**PLANNING APPROVAL,
PLANNED UNIT DEVELOPMENT &
SUBDIVISION STAFF REPORT**

Ebenezer AME Zion Church
(Clarence J. Cooke, Sr., Agent)

268 St. Charles Avenue
(South side of St. Charles Avenue, 365' ± East of St. Stephens Road)

Parking lot expansion for an existing church

SITE PLAN

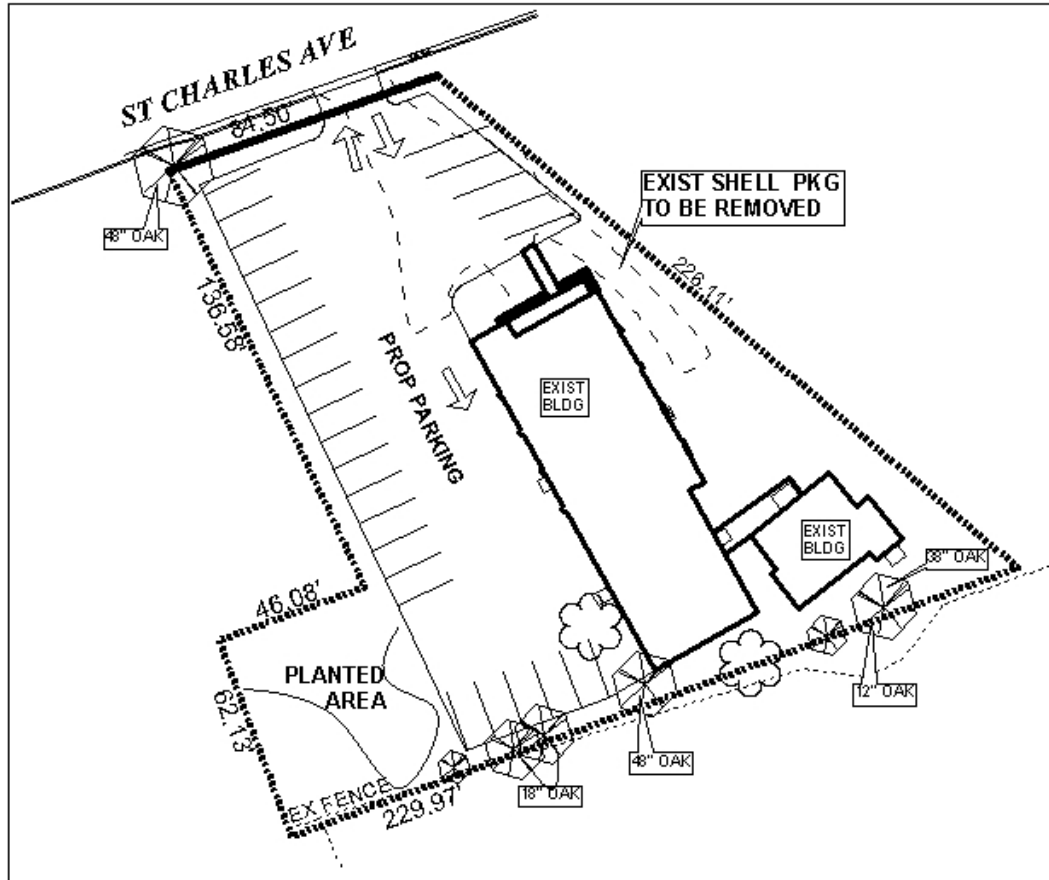
The proposed plan consists of 24 new parking spaces, the sanctuary seats 60 thus adequate parking is provided. Additionally, the applicant notes that the parking will be striped and curbed. Access to the parking area is via a two-way, 19.7foot wide curb cut; two-way curb cuts must be a minimum of 24-feet wide, thus the curb cut should be widened, with the location and design to be approved by Traffic Engineering.

The site adjoins residential property to the West and East thus the provision of buffering in compliance with Section IV.D.1. should be required. Additionally, across the street from the site is residential, thus the provision of a three-foot high privacy fence or hedge should be required to screen the parking area.

In terms of the Subdivision approval, the applicant is consolidating multiple parcels into one lot. St. Charles Avenue has only 40-feet of right-of-way and is thus substandard; therefore, the dedication of sufficient right-of-way to provide 25-feet from the centerline should be required.

Planning Approval: Based upon the preceding, this application is recommended for approval subject to the following conditions: 1) that the parking be paved, striped and curbed; 2) that the curb cut be widened to 24-feet, with the location and design to be approved by Traffic Engineering; 3) provision of frontage trees along St. Charles Avenue; 4) the provision of a buffer where the site adjoins residential development; 5) the provision of a three-foot hedge or privacy fence along St. Charles Avenue; and 6) full compliance with all municipal codes and ordinances.

Planned Unit Development: Based upon the preceding, this application is recommended for approval subject to the following conditions: 1) that the parking be paved, striped and curbed; 2) that the curb cut be widened to 24-feet, with the location and design to be approved by Traffic Engineering; 3) provision of frontage trees along St. Charles Avenue; 4) the provision of a buffer where the site adjoins residential development; 5) the provision of a three-foot hedge or privacy fence along St. Charles Avenue; and 6) full compliance with all municipal codes and ordinances.

Subdivision: The plat meets the minimum requirements of the Subdivision Regulations and is recommended for Tentative Approval subject to the following condition: 1) dedication of sufficient right-of-way to provide 25-feet from the centerline of St. Charles Avenue.
